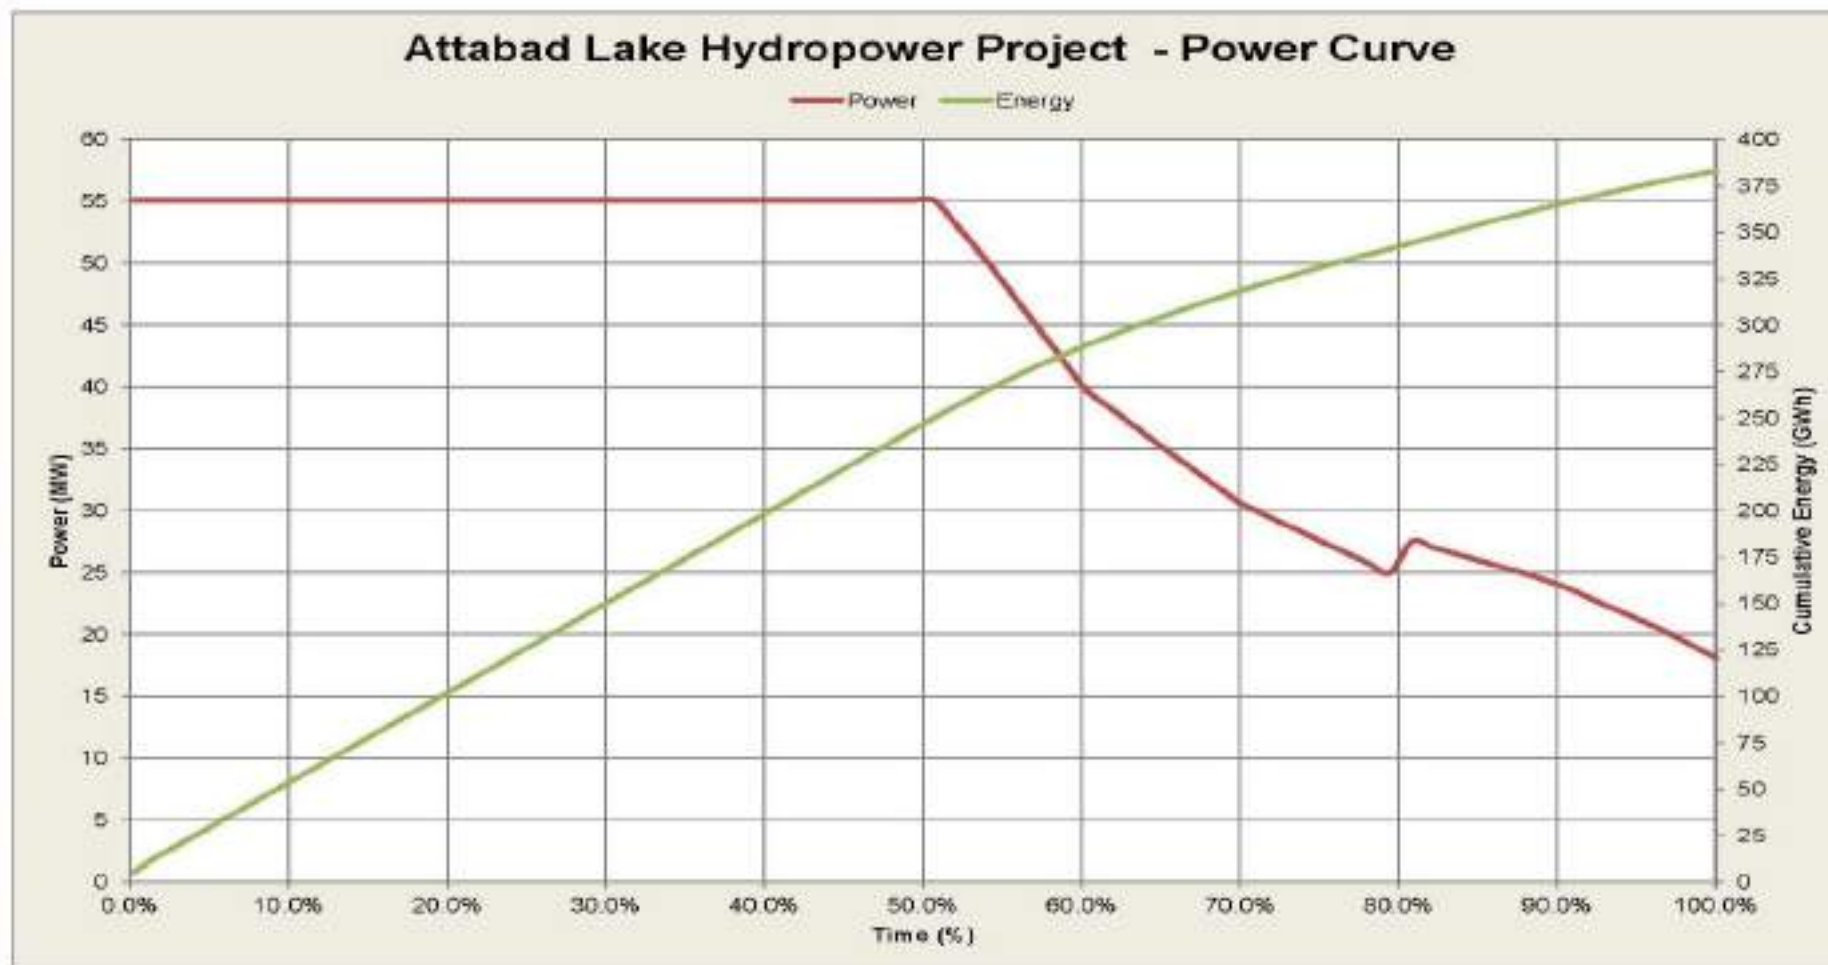
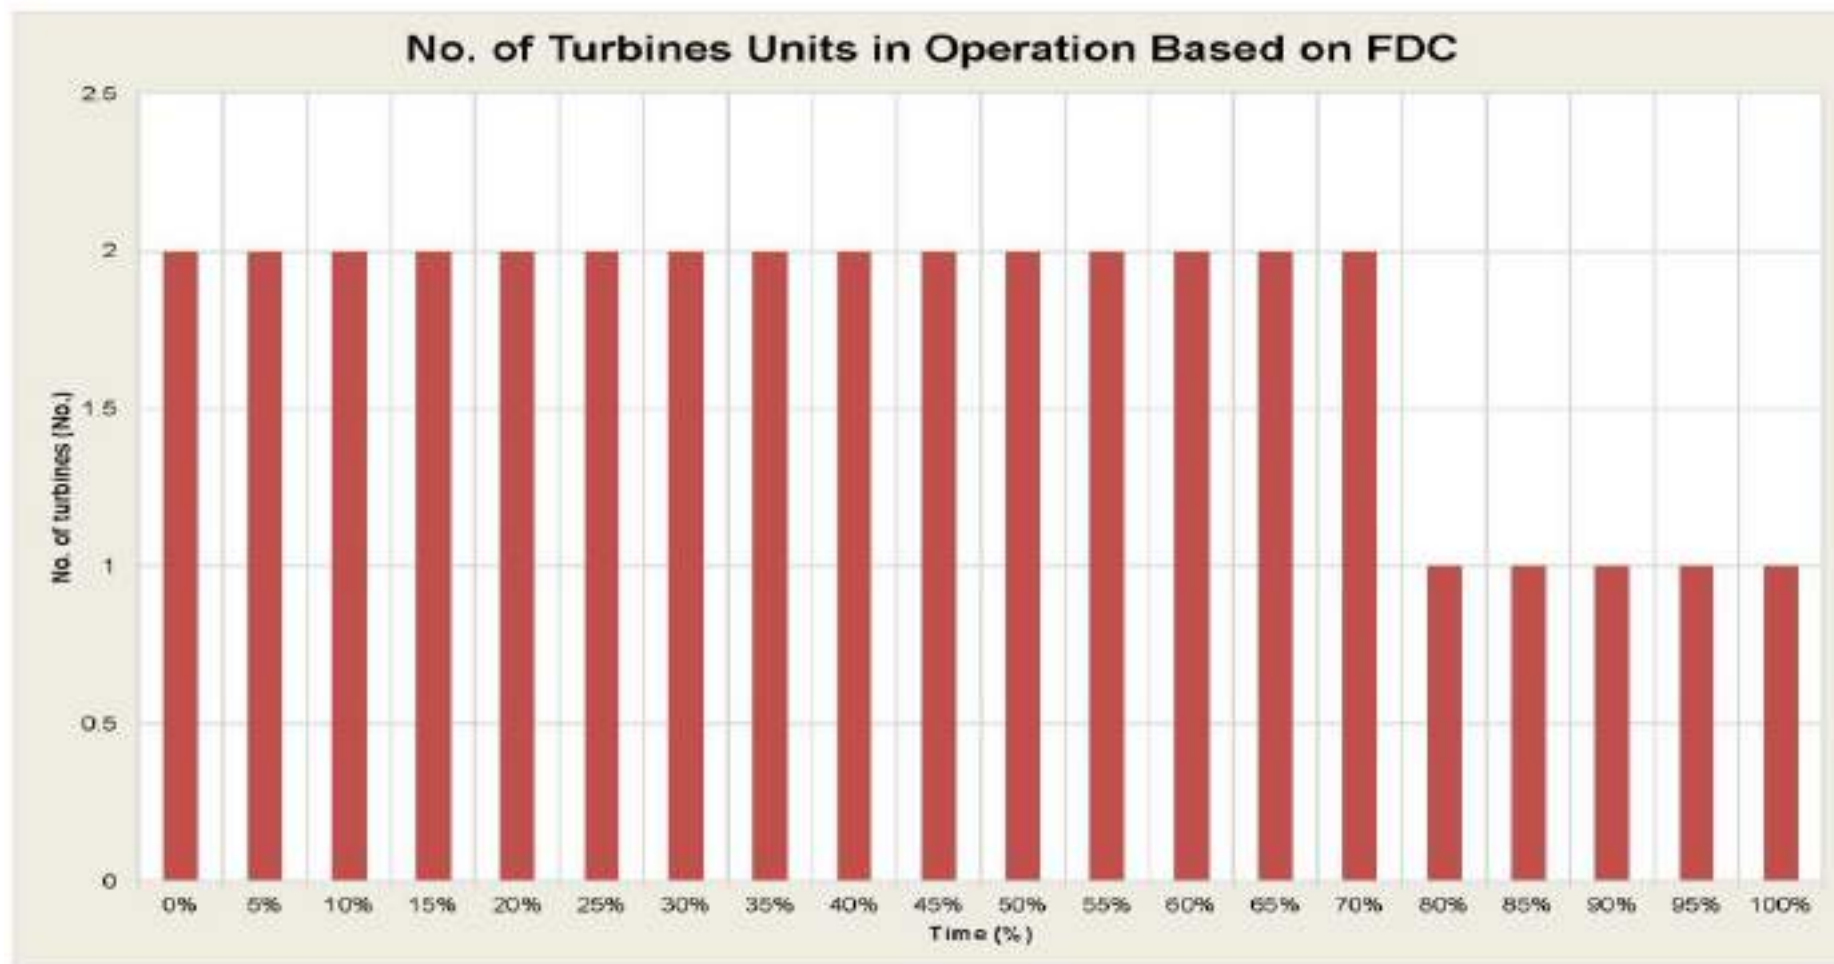
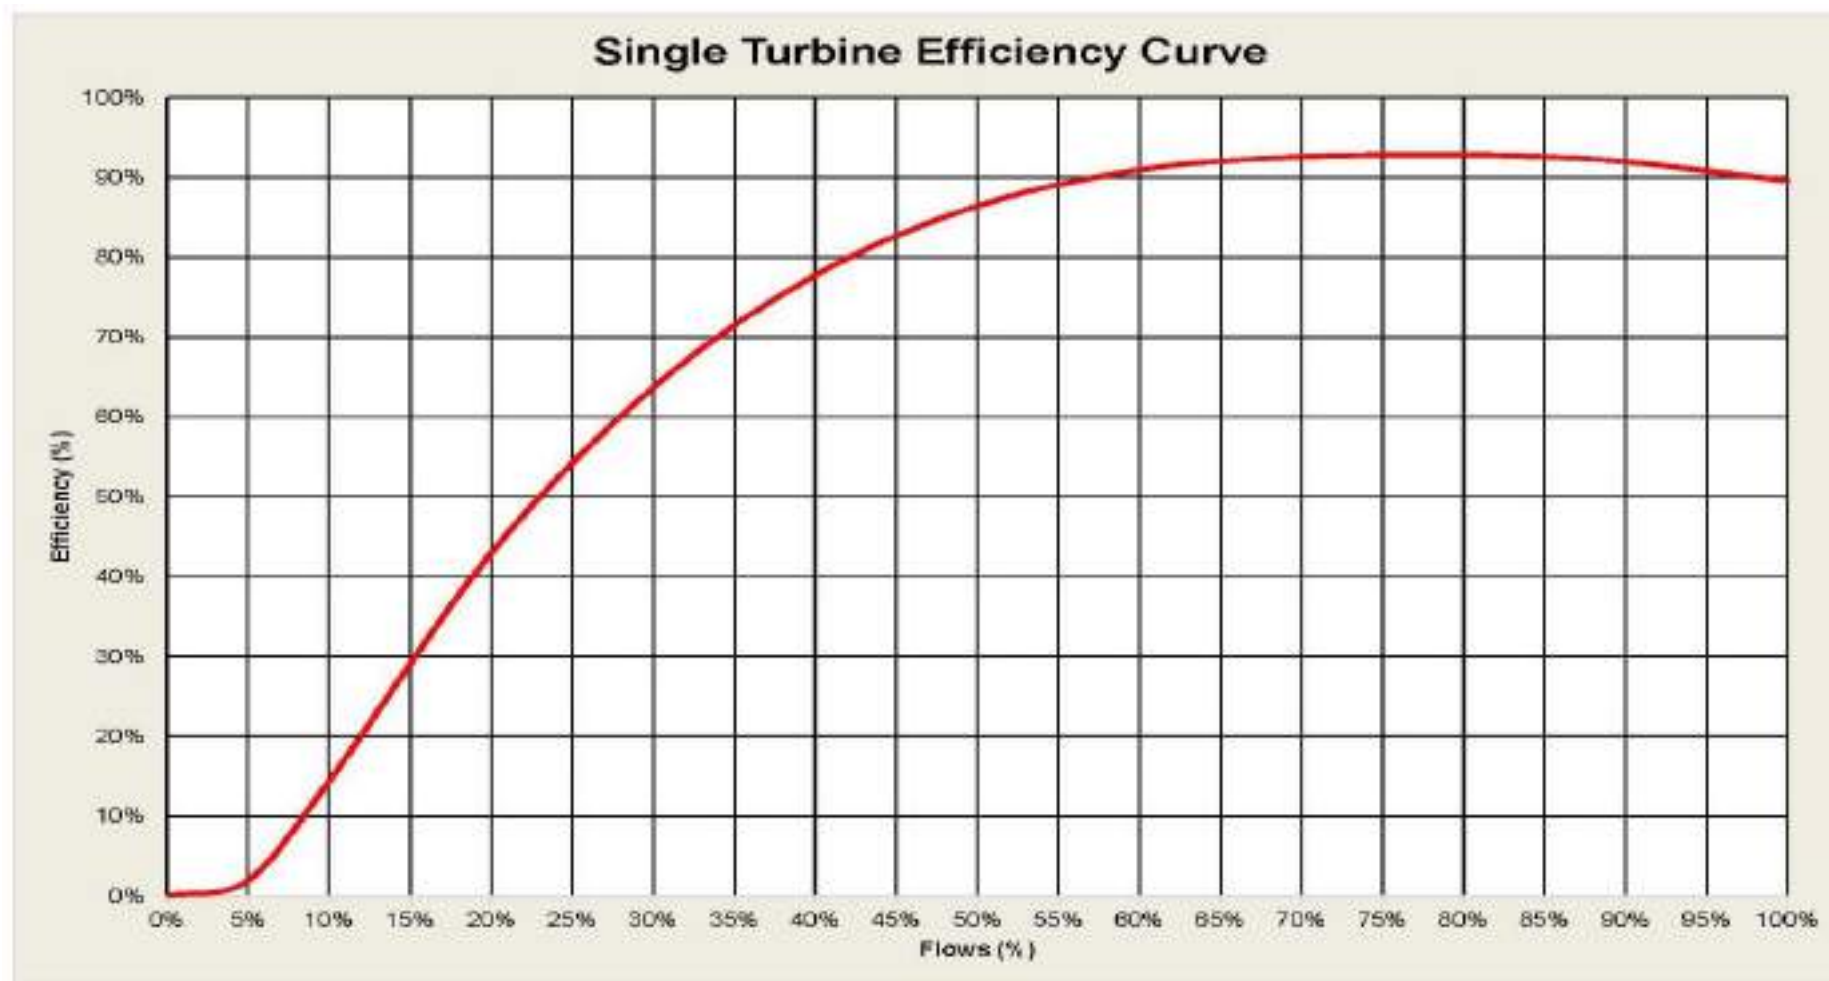
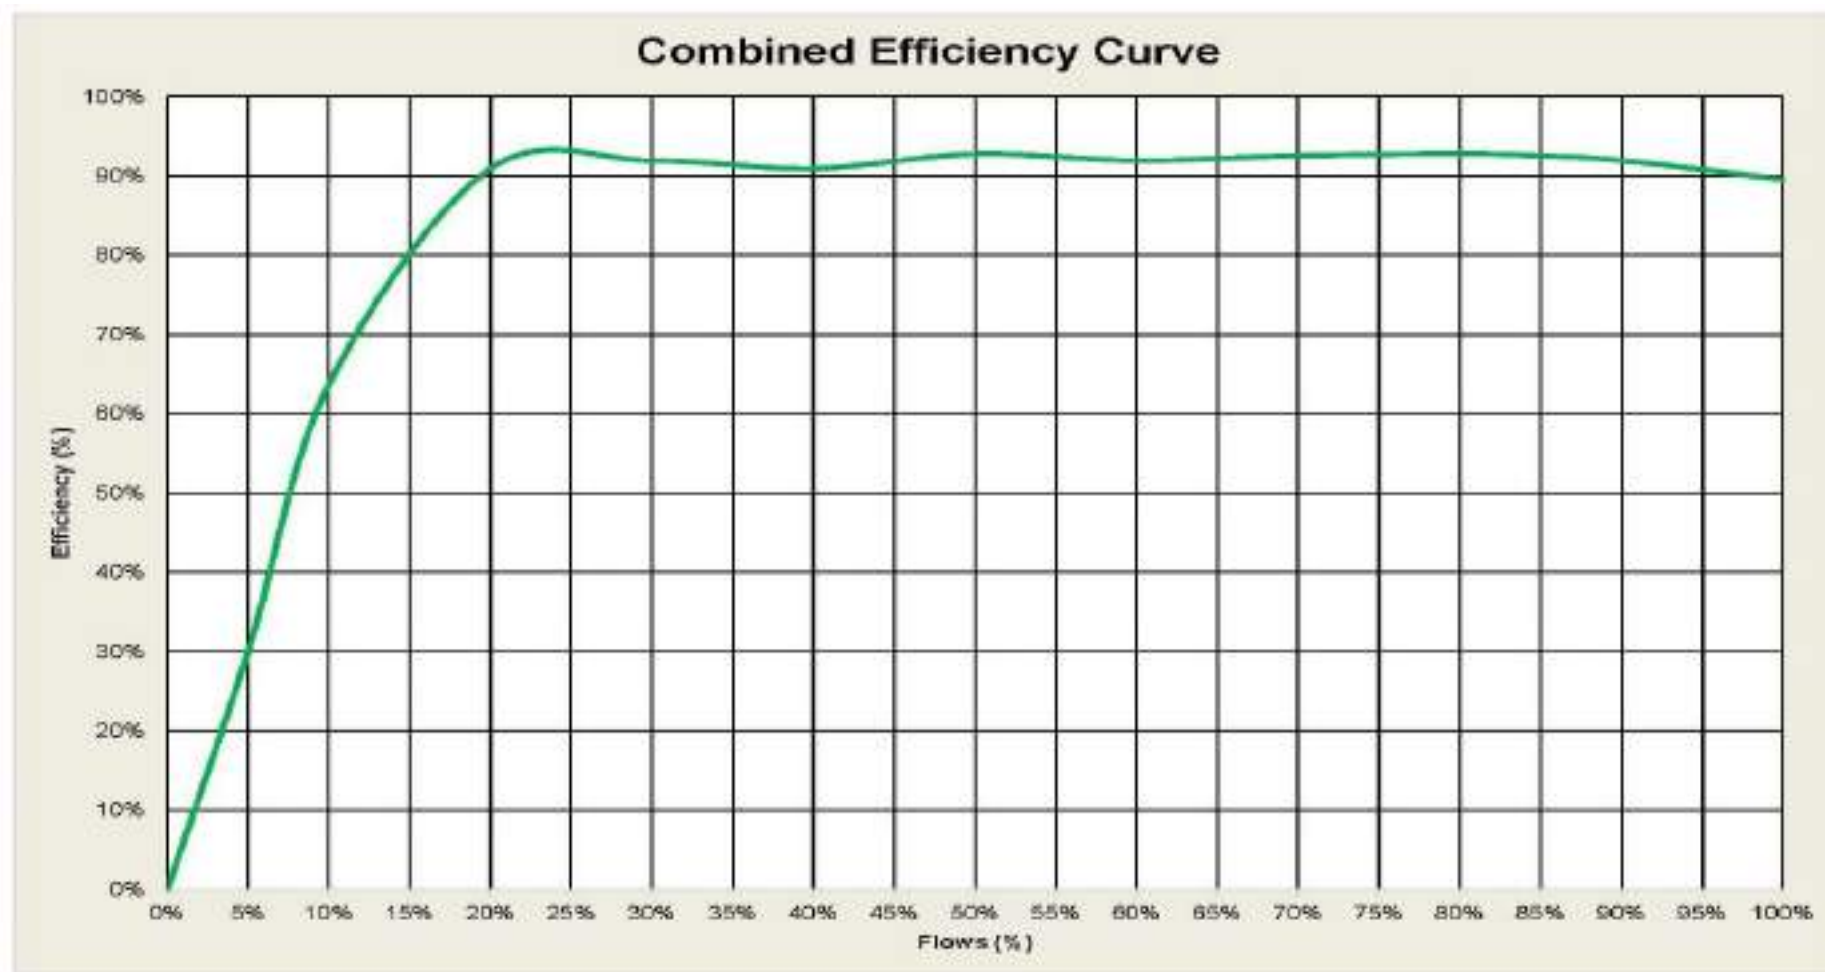
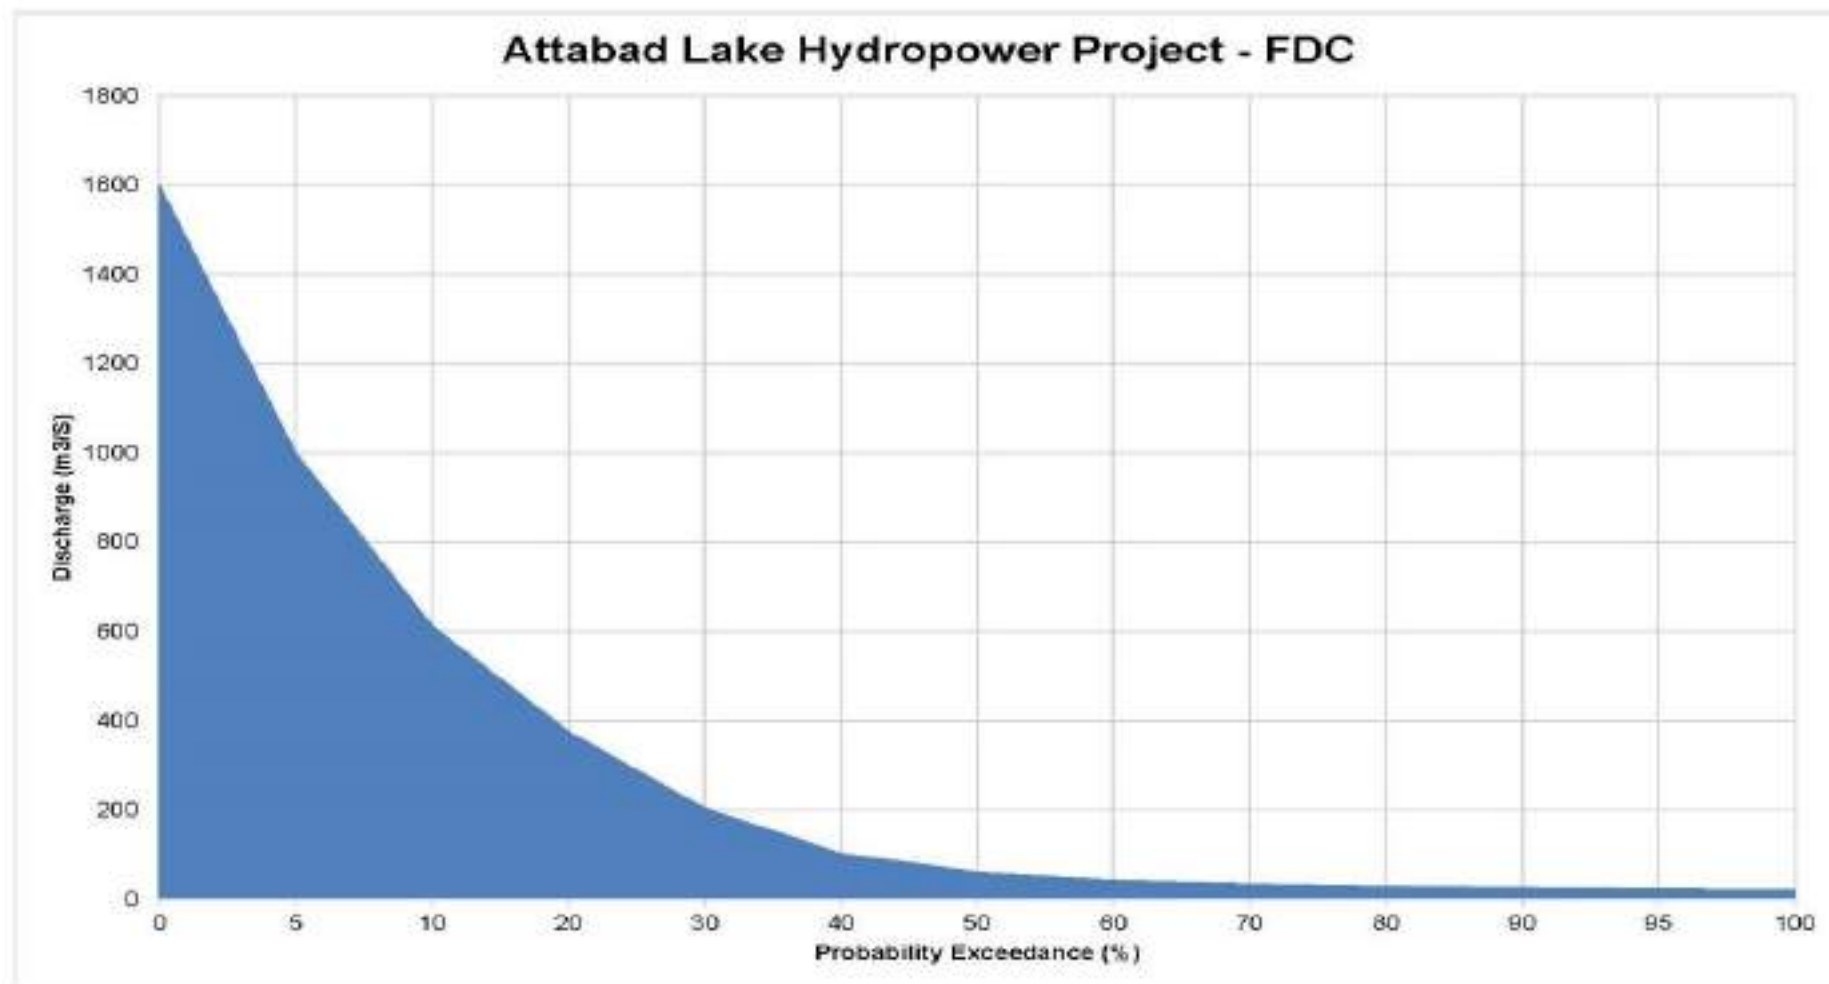
$$\text{Plant Factor} = \frac{372.8 \times 10^6}{54.04 \times 8760000} = \frac{\text{Actual Energy}}{\text{Theoretical Energy}}$$

Plant Factor = **78.74%**
